From: Grubert, Libby [REDACTED]
Sent: Tuesday, 10 November 2020 4:26 PM
To: Contact Us
Subject: Objection to proposal for 12 Thrower Street West Launceston DA0247/2020
Attachments: 12 Thrower Street - Objection to proposed development .docx

Re: DA0247/2020- 12 Thrower St West Launceston – Proposal Objection

DA0247/2020 - 12 Throrer St, West Launceston – Objection to Proposal

1 site plan
 1 : 200

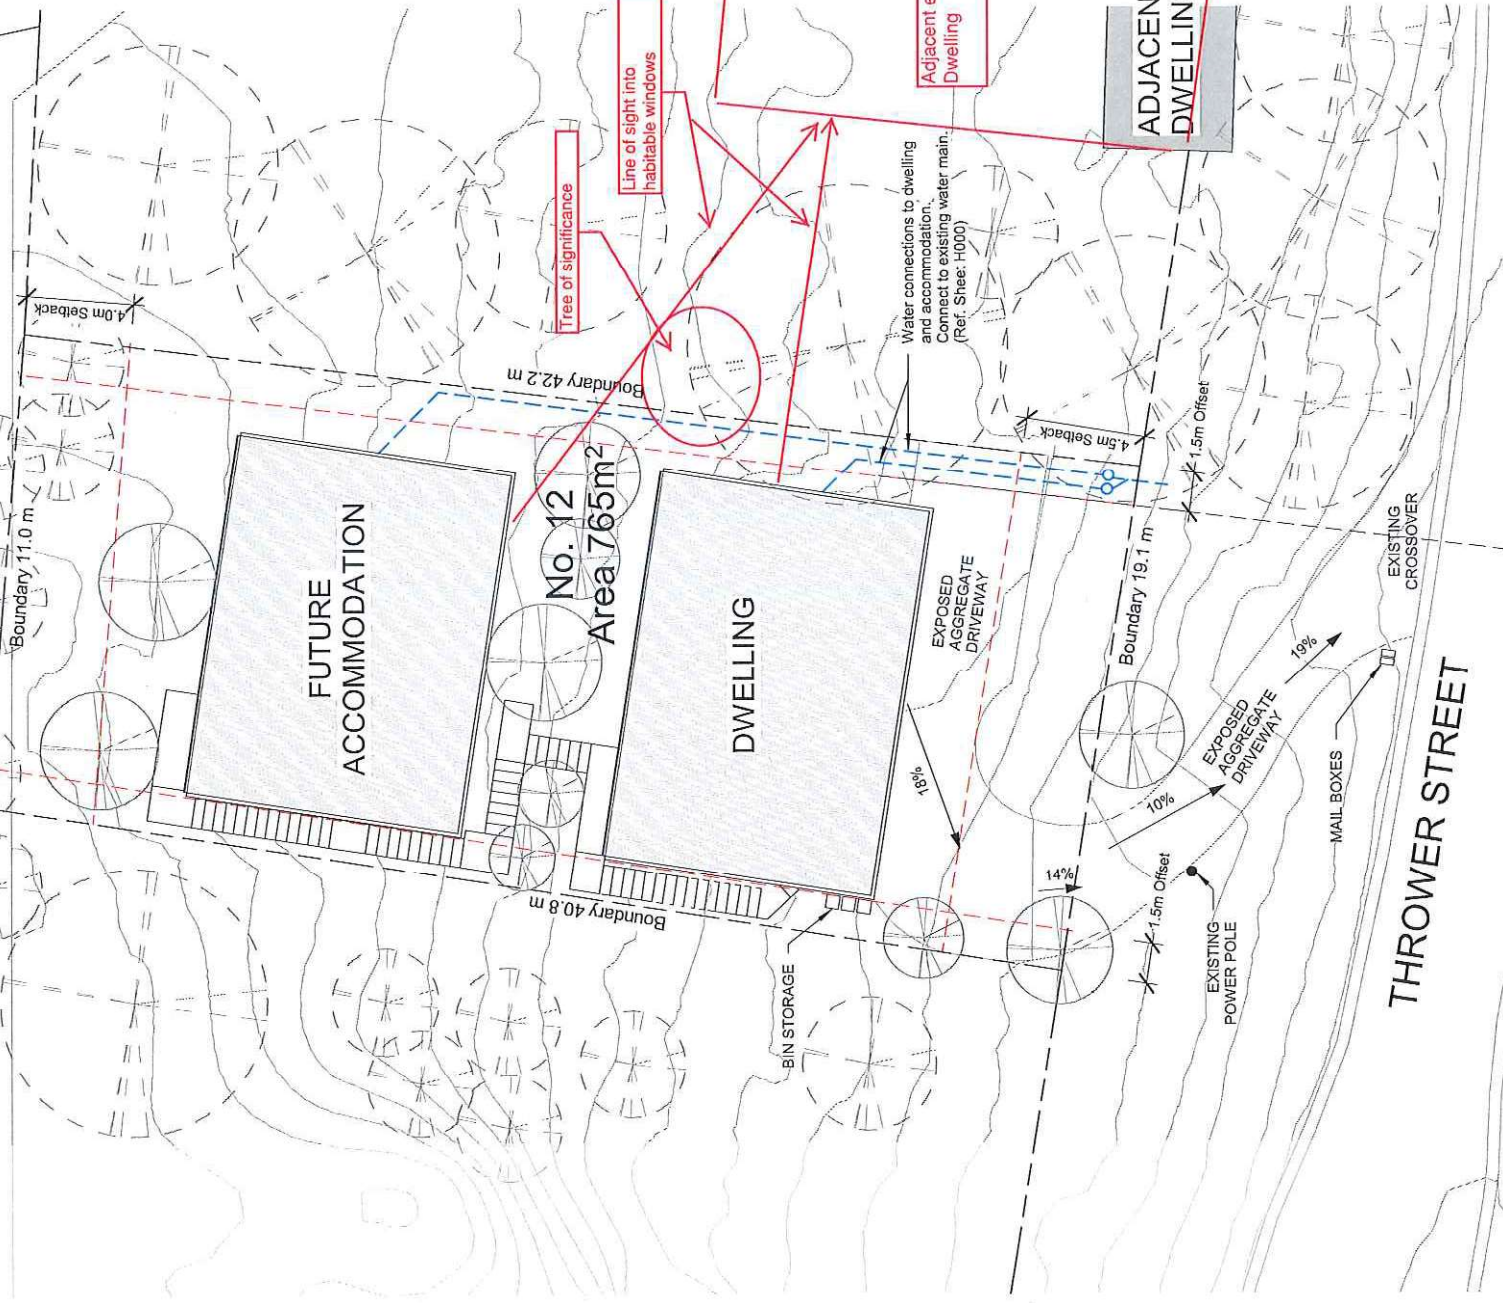
At the proponent's response in section 5.2 (a) it incorrectly states that the proposed dwelling will be upslope and approximately 28m from the adjoining dwelling on the eastern lot. It is also reliant on existing vegetation on the eastern lot for screening. The position of the proposed dwelling in relation to the existing adjoining dwelling on the eastern lot is such that the position of the proposed dwelling will have a direct view into the master bedroom of the dwelling on the eastern lot. The height of the proposed dwelling combined with the proposed reduced eastern side setback will only amplify the intrusion to privacy on the adjoining eastern dwelling. The vegetation screening referred to as assisting in the minimisation of amenity is also false as the vegetation in the area described is largely deciduous or shrub of non-significant height. Further the drawings supplied with the application are grossly inaccurate with the respect to the positioning and size of the eastern dwelling in relation to the proposed development.

At the proponent's response in section 5.2 (b) it incorrectly states that the proposed dwelling will be positioned with an orientation that avoids direct views toward the dwelling on the eastern lot. This is inaccurate as the position of the proposed dwelling will be located directly opposite and at relatively the same height as the existing adjacent dwelling on the eastern lot. This combined with the height and proposed reduced eastern side set back will the significantly reduce the privacy to private open space and windows of habitable rooms on adjoining eastern lot.

At the proponent's response 5.2 (g) it implies that the finished floor level will not shadow the open space amenity of the adjacent eastern lot. This is an inaccurate assessment as the proposed building height will be 3.5m above ground level and combined with the and significantly reduced eastern side set back can only promote a large shadow of the proposed structure on the eastern lot.

The proposed residential development fails to mention the construction of a garage on the eastern boundary, yet one is shown in the in drawing A102 of the application. With consideration that the proponent has already asked to relax the required side offset from the boundaries, it is unclear where this garage will be located, however looking at the drawing one can only assume it will be excavated to the boundary on the east of the lot as it is marked off the eastern wall of the house.

1 site plan
 1 : 200

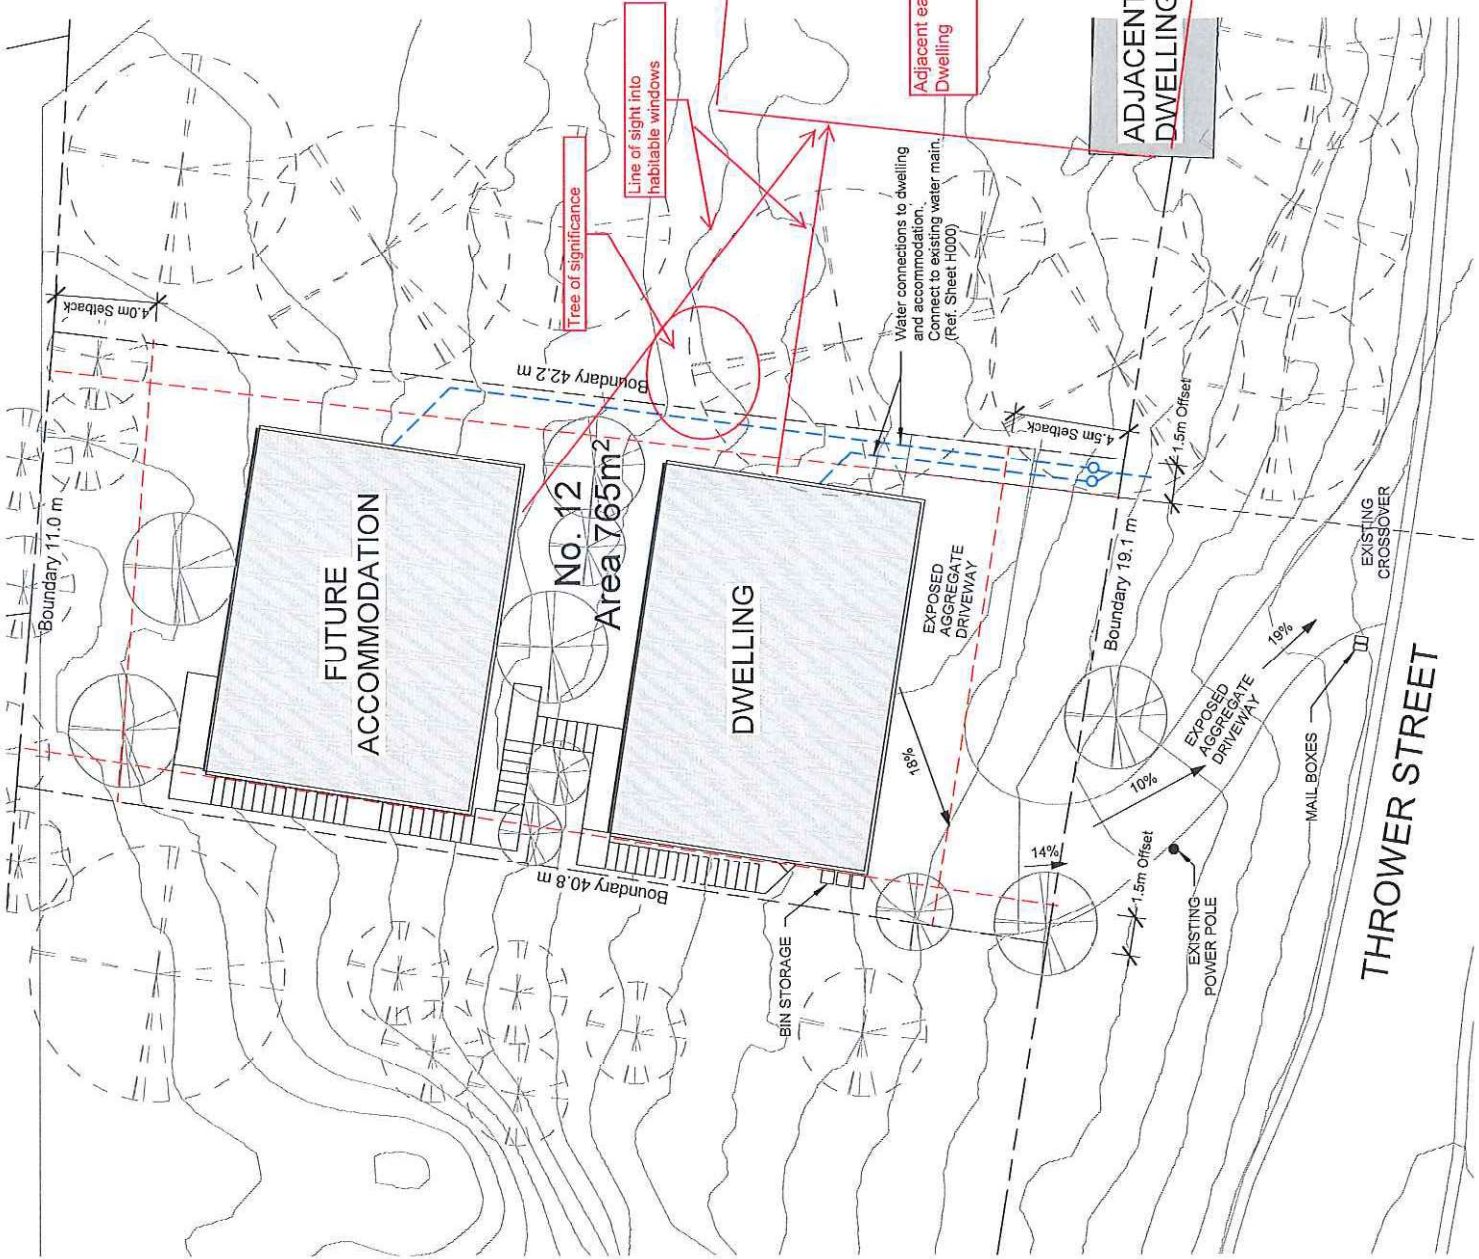
Please find attached a drawing submitted by the proponent with an overlay outlining the approximate location of the existing dwelling on the eastern lot as well as the lines of sight mentioned within this objection and the approximate location of the significant tree also mentioned throughout this letter of objection. The attached marked up drawing very clearly shows the concerns I have surrounding my privacy and amenity from the proposed developments. In representing these considerations to Council, I have tried to be as accurate as possible and I trust you will give due consideration to the information given.
